Montclair State University
Center for Environmental and Life Sciences

Projectmates Transmittal Cover Sheet

Category	095113-0104-a - reflected ceiling plan shop drawings (02 - Shop Drawings)	X Delete
	Attachments: CELS-Master RCP (00061907).pdf Open	
Edit Submittals Items

APPROVAL STATUS	RESPONSE REQUIRED OF CONTRACTOR
<input type="checkbox"/> APPROVED	<input type="checkbox"/> REVISE AND RESUBMIT
<input checked="" type="checkbox"/> APPROVED AS CORRECTED	<input type="checkbox"/> SUBMIT SPECIFIED ITEM
<input type="checkbox"/> NOT APPROVED	<input type="checkbox"/> RESUBMIT FOR RECORD WITH ALL CORRECTIONS INCORPORATED
<input type="checkbox"/> NO ACTION TAKEN

406 TYP AGT CEILING I-LAG FASTENER @ METAL ROOF DECK
NOT TO SCALE

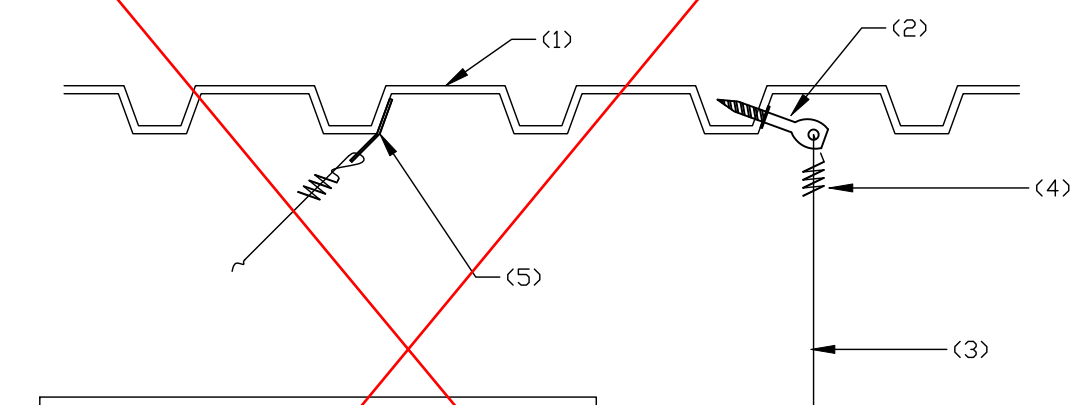
Attaching to the roof deck is NOT allowable
